Amendment Report

In-fill Affordable Housing
5-9 Cowan Road, St Ives
SSD 88948458

Prepared for Prosper 5-9 Cowan Road
St Ives Pty Ltd (646 866 241 26)

April 2026

Figure 5: Affordable Housing GFA Diagram - Ground Floor (Source: PBD Architects)

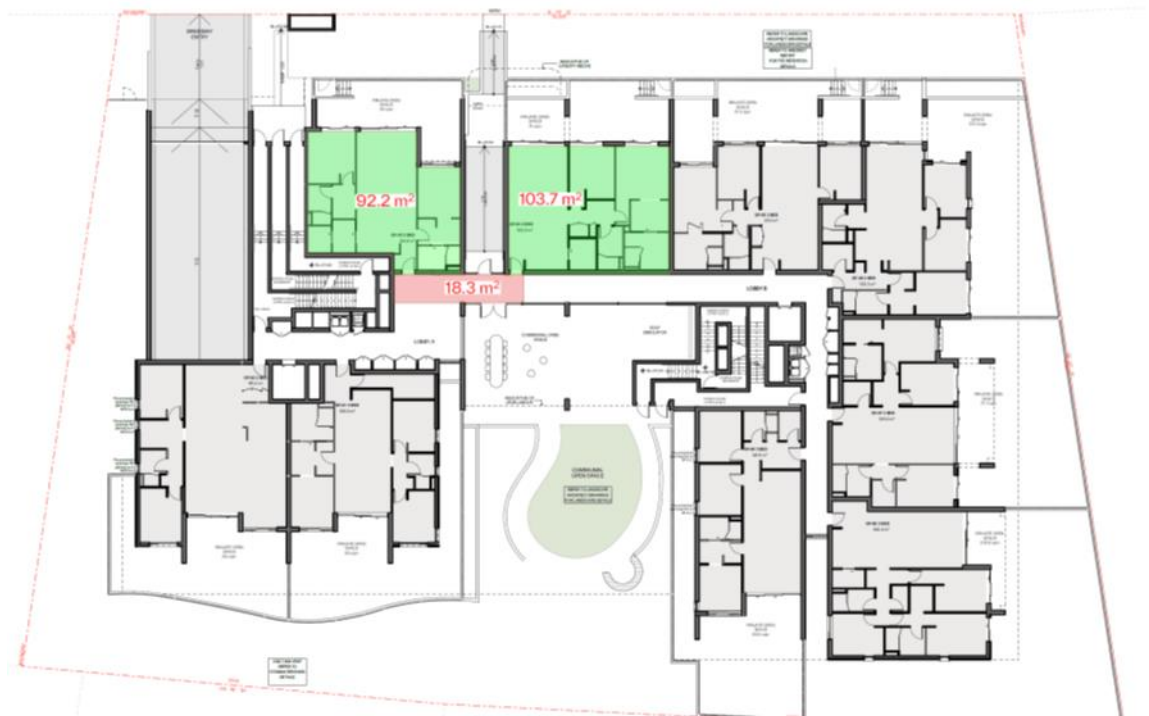
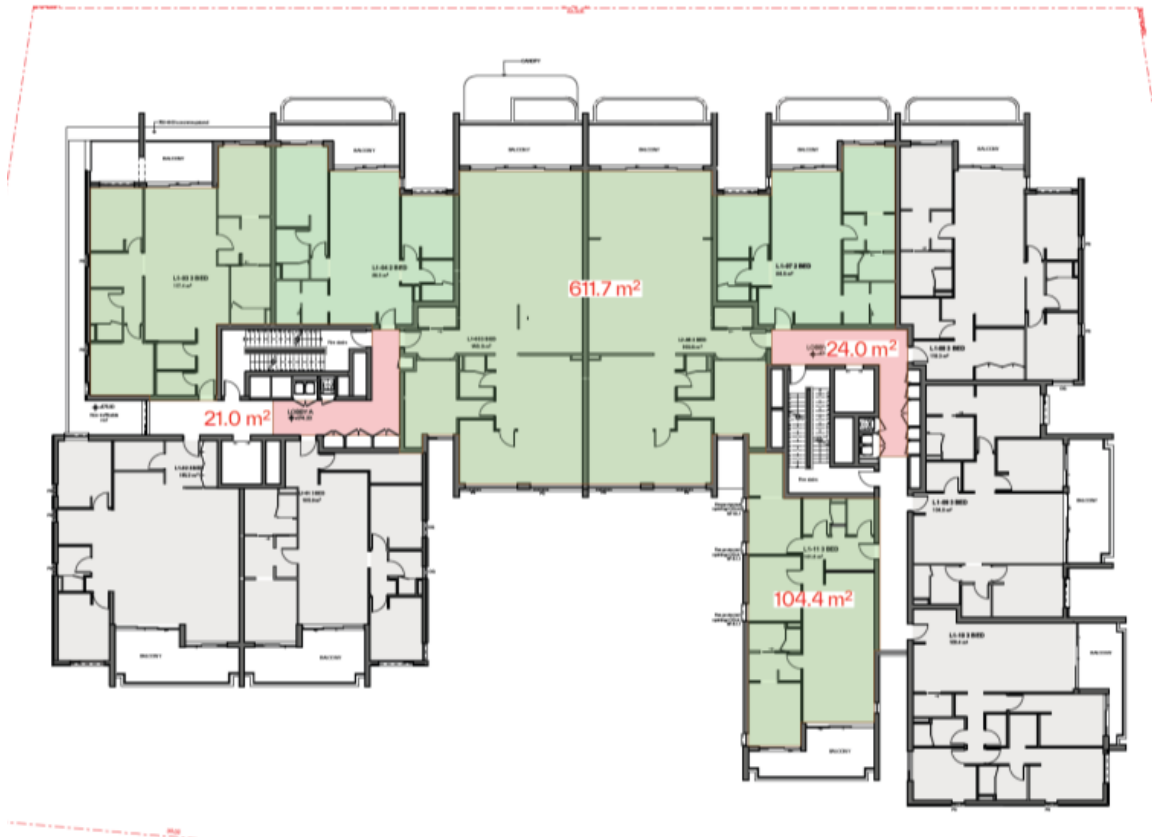
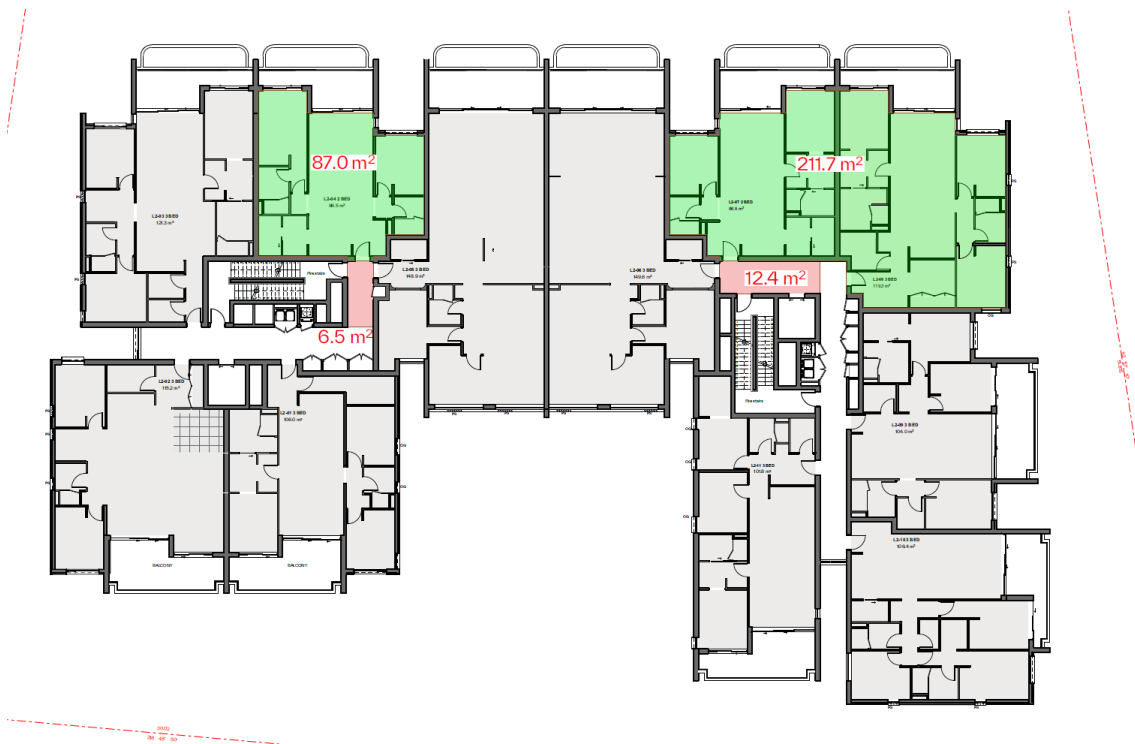
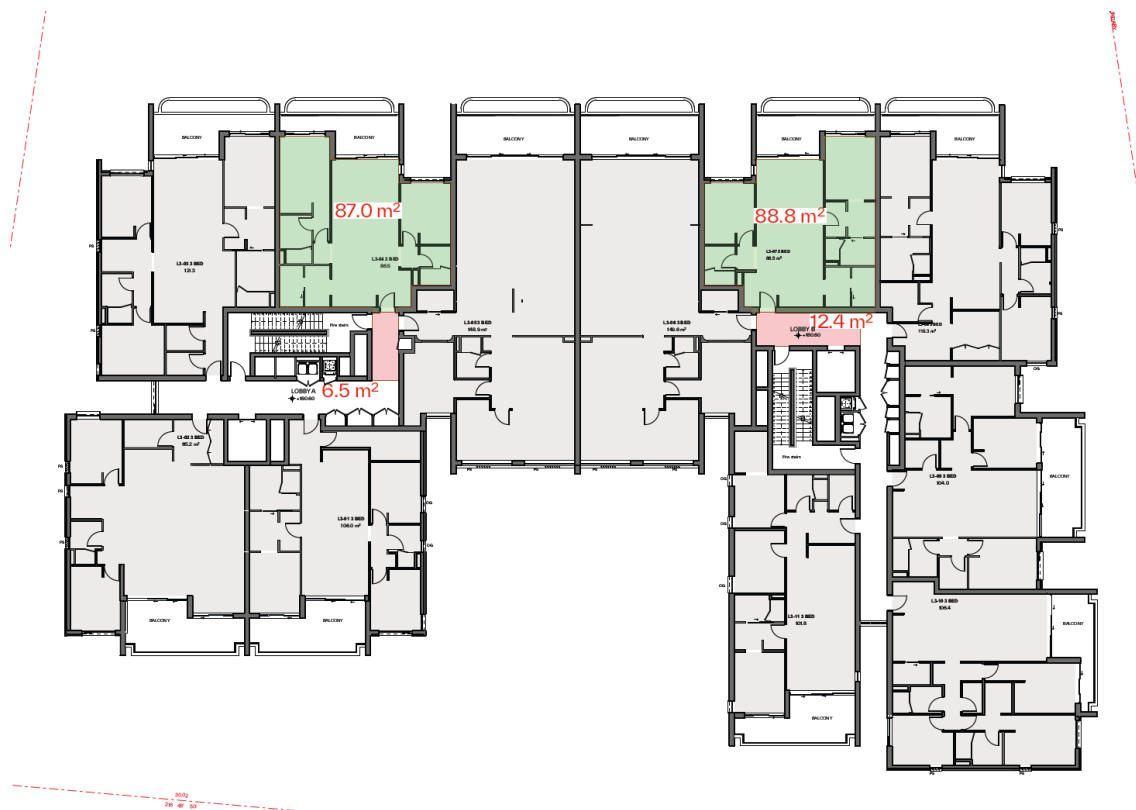
The floor area has been maintained whilst facilitating an additional two apartments at Level 8. This is a result of the increased setbacks at the south-western boundary and revised communal open space area at ground floor which is now open to the elements and therefore does not constitute GFA. This allows the proposal to continue to maintain a compliant FSR with the maximum FSR provision.

- GFA (total): 9917.6 m²
- Market housing GFA: 8,430m²
- Affordable housing GFA: 1487.6m²

Figure 10: Section 3 (Source: PBD Architects)

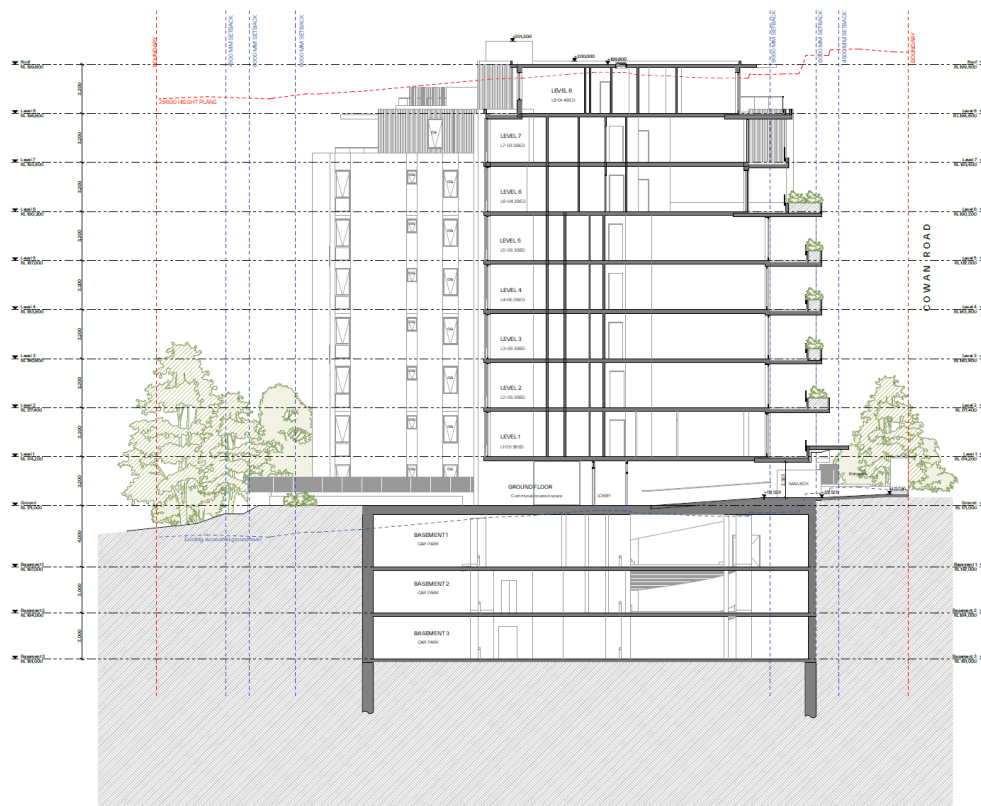
A minor increase of approximately 1m to the proposed height of the development (from 29.69m to 30.60m) has been made to facilitate lift access to additional apartments at level 8. This will result in no additional environmental impacts as demonstrated in the shadow diagrams within the updated Architectural Plans (Appendix 4). The proposed change does not result in any additional overshadowing to surrounding properties or public spaces from that originally assessed and does not give rise to adverse visual or amenity impacts.

Figure 15: Exceedance of building height (Source: PBD Architects)

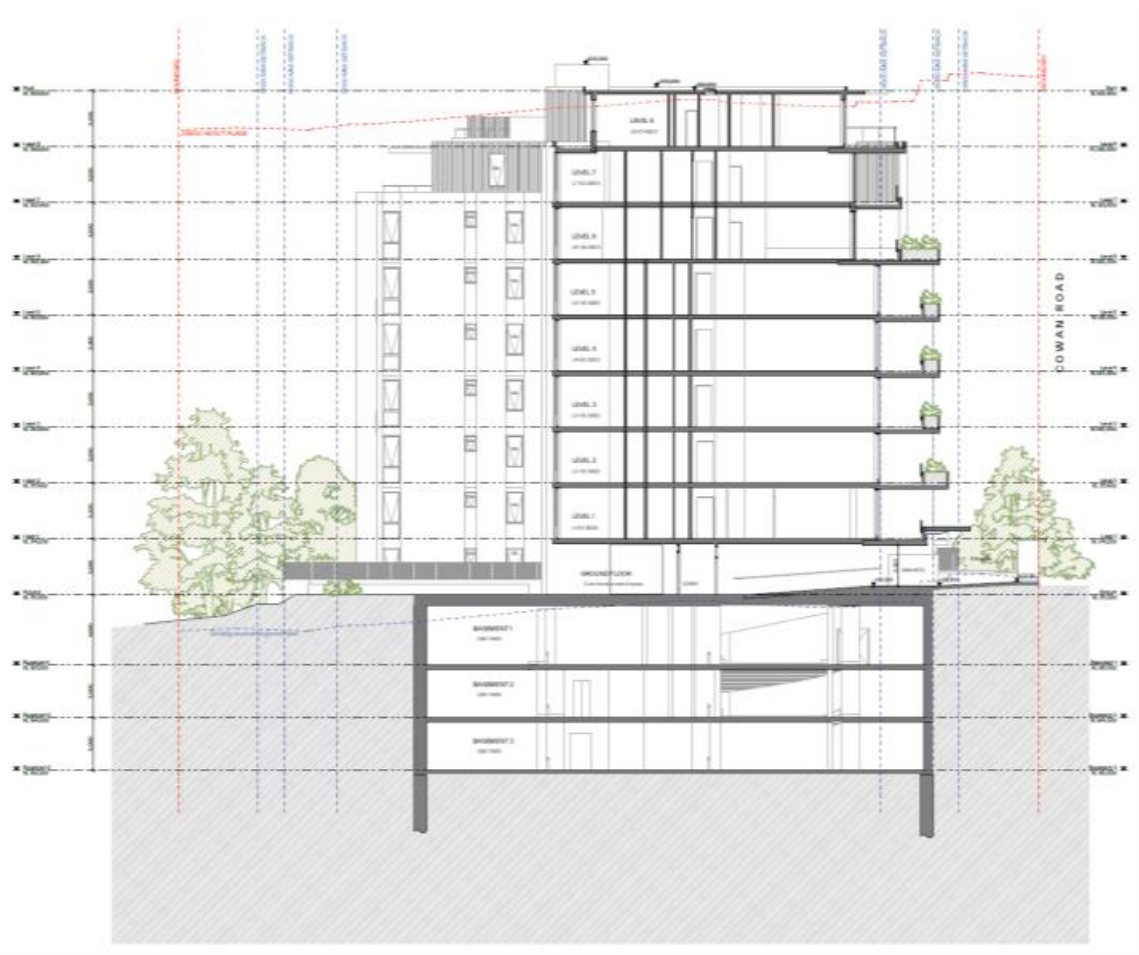
- Non-discretionary standards, Chapter 6 Housing SEPP (Base control): 22m
- 30% incentive bonus, Chapter 2 Housing SEPP: 6.6m
- Maximum height (including 30% bonus): 28.6m
- Proposed amended building height: 30.60m

The proposed building height is justified in the revised Clause 4.6 Variation request at Appendix 19. It is noted that the increase from that originally proposed is minor and has been made to facilitate lift access to additional apartments and communal open space at level 8.

Figure 16: Level 7 floor plan with skylights circled in red (Source: PBD Architects)

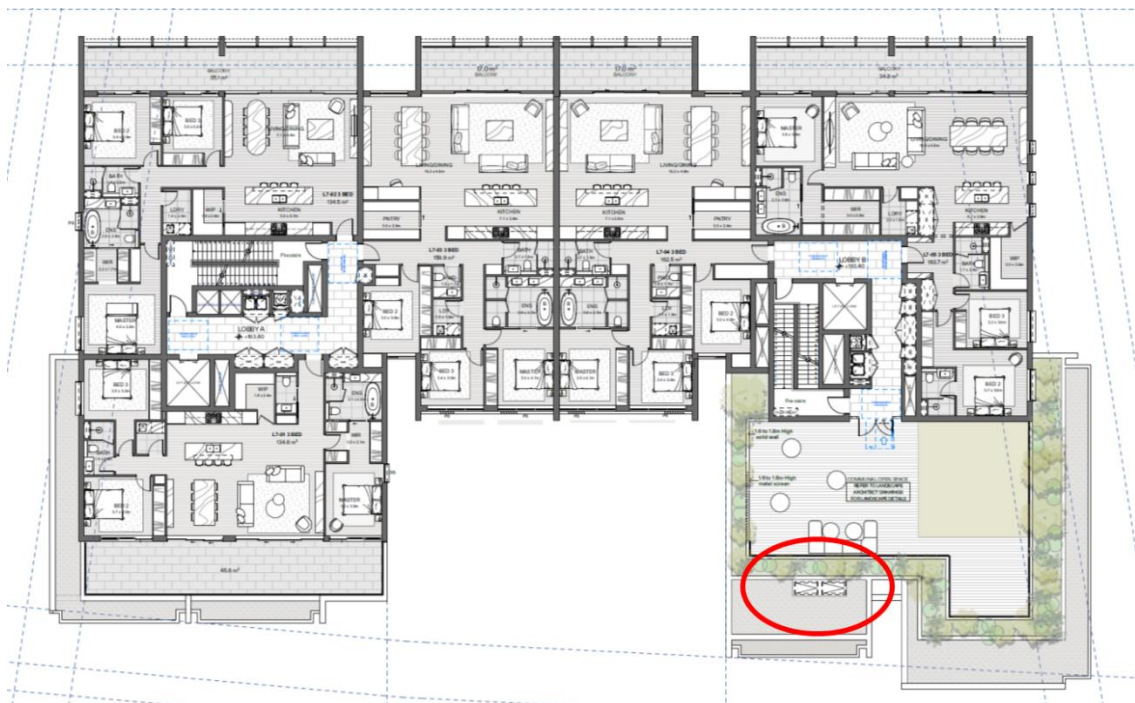
Additionally, Unit 8 on Level 6 has been provided with secondary light sources in the form of skylights. This continues to ensure this apartment achieves improved amenity in terms of solar access. If this was not included in ADG solar access calculations, the total number of apartments achieving a minimum 2 hours of solar access during mid-winter would be 70%, continuing to meet ADG minimum requirements.

Figure 19: Shadow diagrams (Source: PBD Architects)

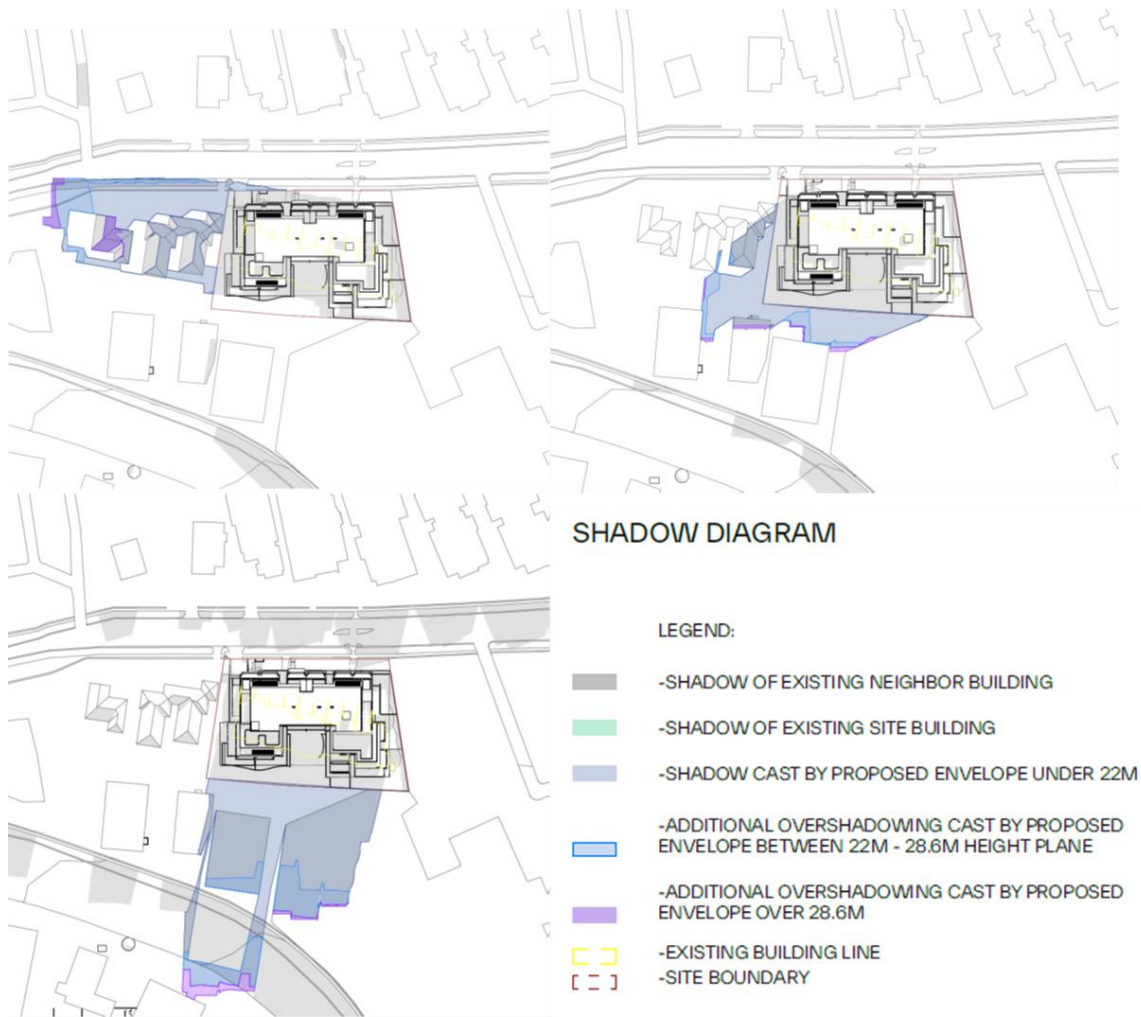
The revised shadow diagrams provided at Appendix 4 demonstrate the minor increase from those originally proposed results in negligible additional solar access impacts. The extent of the variation is localised and contained centrally within the development resulting in any perceivable impact on shadows cast by the proposal. This has ensured that offsite impacts are negligible and are comparable to a compliant scheme.

Shadow diagrams showing shadows cast by a compliant scheme and the proposal have been provided which demonstrate that the additional shadows are minimal and negligible in the context of the site and surrounds which have been identified for uplift in accordance with the low and mid-rise housing provisions.

Figure 21: Level 7 communal open space (Source: PBD Architects)

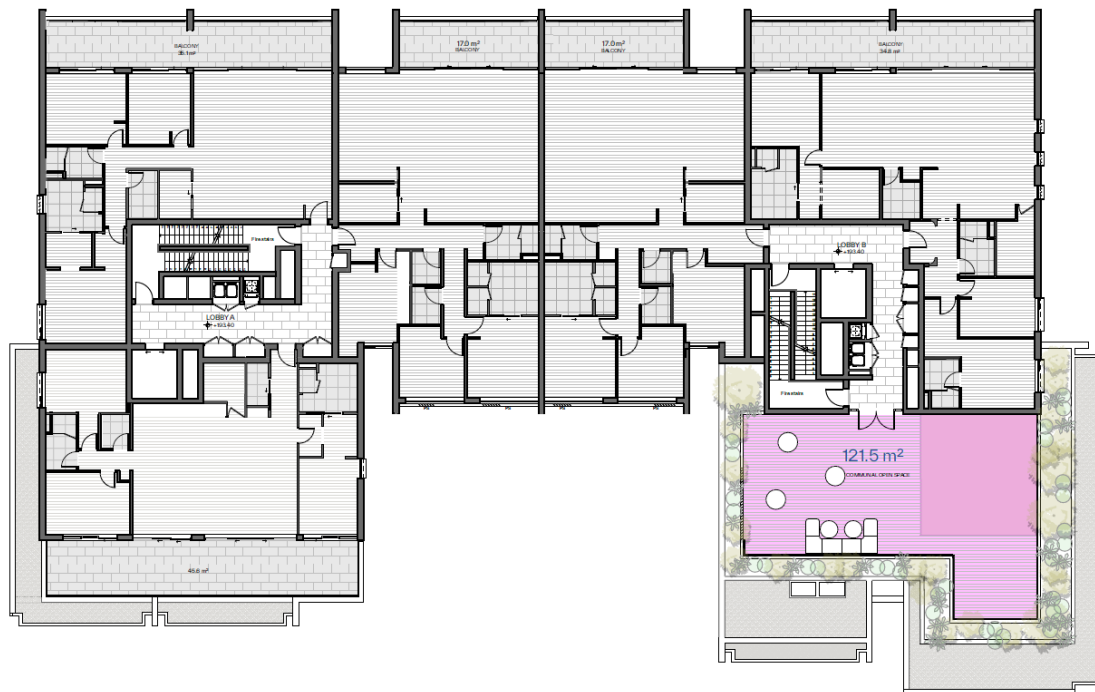
The planting to the Level 7 communal open space has been revised in response to the recommendations of the wind report, particularly addressing north-east and southern summer wind conditions.

A tailored planting mix has been selected to achieve a minimum height of 1.5 m above the finished floor level along the perimeter noting that each area of COS is provided with 500mm raised planters, enhancing wind mitigation and overall comfort for users, and ensuring the amenity of future residents when utilising the communal space.
